HLC Review Addendum 07 Oct 2026

4309 Avenue D Item HR-2026-104982

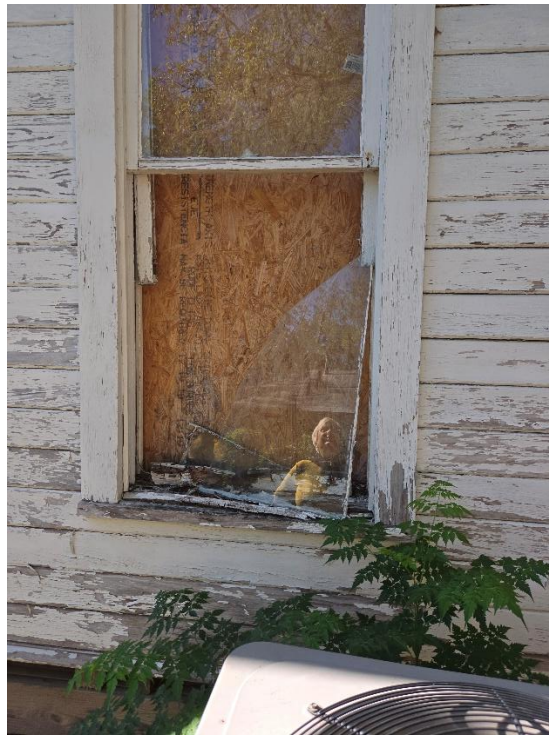
1.2 The second front door is not original to the 1912 home and was added around the time of the Great Depression in 1929. While it is old, it is not original. It enters directly into bedroom and is not in character with the 1912 house Queen Anne-esque house.

Our rehabilitation of this home (back to single family) includes restoring the original transom in the entry foyer over the original front door. See picture....

The secondary door is a five panel interior non-weather rated door taken from another bedroom. Probably done when Clara Stubbs divided the house for daughter Clara to live there ? There was never a transom over the secondary narrower door.
